UNITED STATES
DEPARTMENT OF THE INTERIOR
BUREAU OF LAND MANAGEMENTREC'D NMOCD
11/16/2020FORM APPROVED
OMB NO. 1004-0137
Expires: January 31, 2018**SUNDRY NOTICES AND REPORTS ON WELLS**
Do not use this form for proposals to drill or to re-enter an abandoned well. Use form 3160-3 (APD) for such proposals.5. Lease Serial No.
NMNM05039A

7. If Unit or CA/Agreement, Name and/or No.
891000303X8. Well Name and No.
POKER LAKE UNIT 21 BD 106H9. API Well No.
30-015-45697-00-X110. Field and Pool or Exploratory Area
PURPLE SAGE-WOLFCAMP (GAS)11. County or Parish, State
EDDY COUNTY, NM**SUBMIT IN TRIPLICATE - Other instructions on page 2**

XTO Permian Operating, LLC, requests permission to make the following changes to the original APD:

DRILLING PLAN: BLM COMPLIANCE
(Supplement to BLM 3160-3)

Wellhead diagram during skidding operations

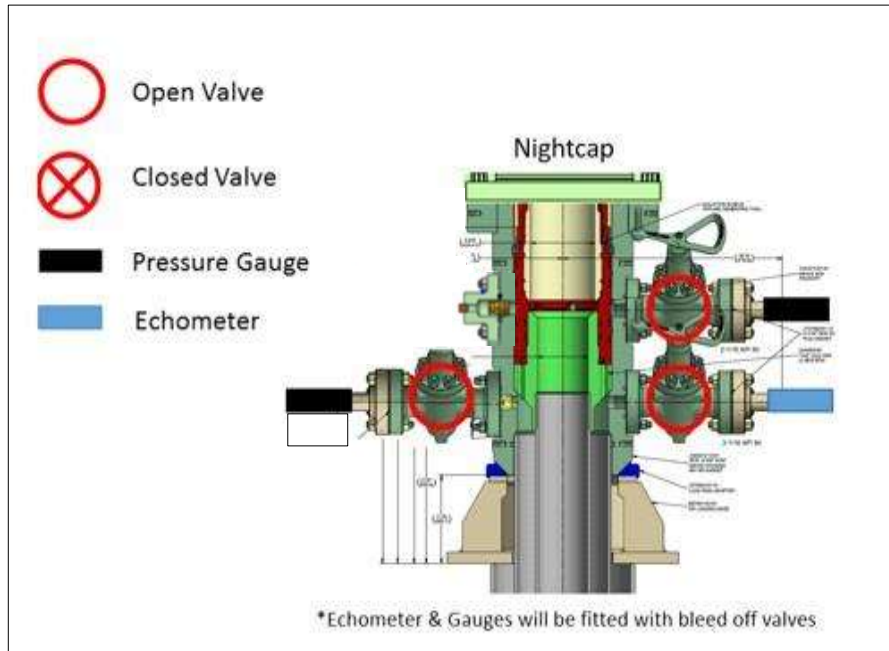
6. Skid rig to next well on pad.
7. Confirm well is static before removing cap flange, flange will not be removed and offline cementing operations will not commence until well is under control. If well is not static, casing outlet valves will provide access to both the casing ID and annulus. Rig or third party pump truck will kill well prior to cementing or nipping up for further remediation.

Wellhead diagram during offline cementing operations

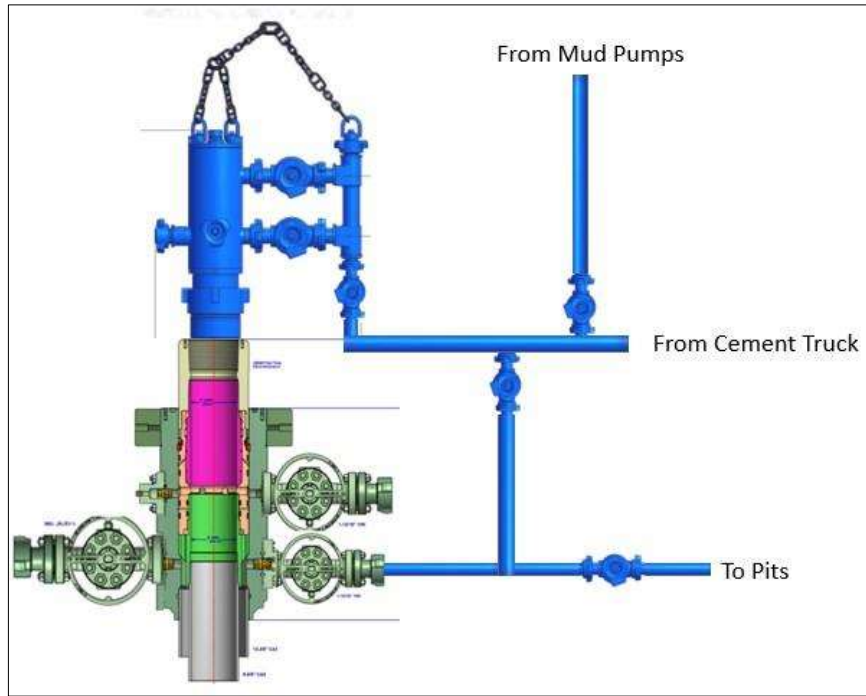
10. Circulate bottoms up with cement truck
 - a. If gas is present on bottoms up, well will be shut in and returns rerouted through gas buster to handle entrained gas
 - b. Max anticipated time before circulating with cement truck is 6 hrs
11. Perform cement job taking returns from the annulus wellhead valve
12. Confirm well is static and floats are holding after cement job
13. Remove cement equipment, offline cement tools and install night cap with pressure gauge for monitoring.
